**SUNDRY NOTICES AND REPORTS ON WELLS**  
*Do not use this form for proposals to drill or to re-enter an abandoned well. Use Form 3160-3 (APD) for such proposals.*

RHODES FEDERAL #265

**PROPOSED PLUG AND ABANDONMENT PROCEDURE:**

RE: Plugging and Abandonment Requirements, Conditions of Approval

Cimarex Energy Co. of Colorado  
Rhodes Federal Unit No. 265  
990' FSL & 955' FWL  
Sec 26 T26S R37E  
Lea County, NM  
API 30-025-33205

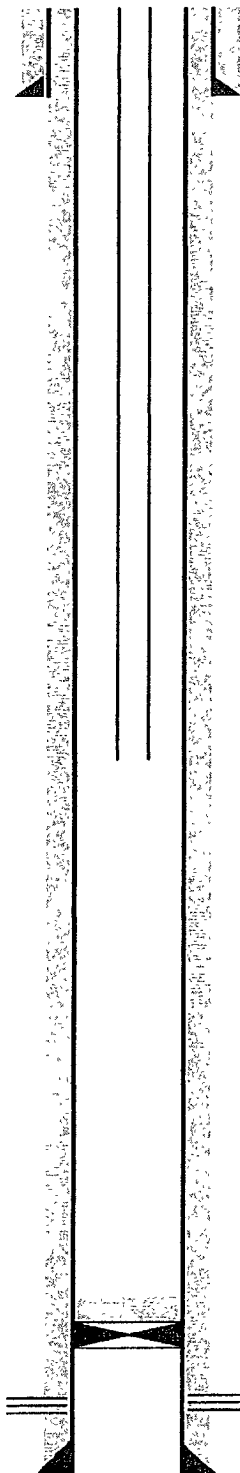
1. OK
2. Tag at 2700' or shallower – Otherwise OK (Perfs – Yates – BOS)
3. Move: Spot a plug from 1550'-1350'. Tag at 1350' or shallower – Otherwise OK (TOS)
4. Move: Spot a plug from 600'-590'. Tag at 590' or shallower – Otherwise OK  
(Casing shoe)
5. OK (Surface)
6. Verify that all annuluses have cement to surface and fill in as required – Otherwise OK.
7. Submit a subsequent report to the BLM.
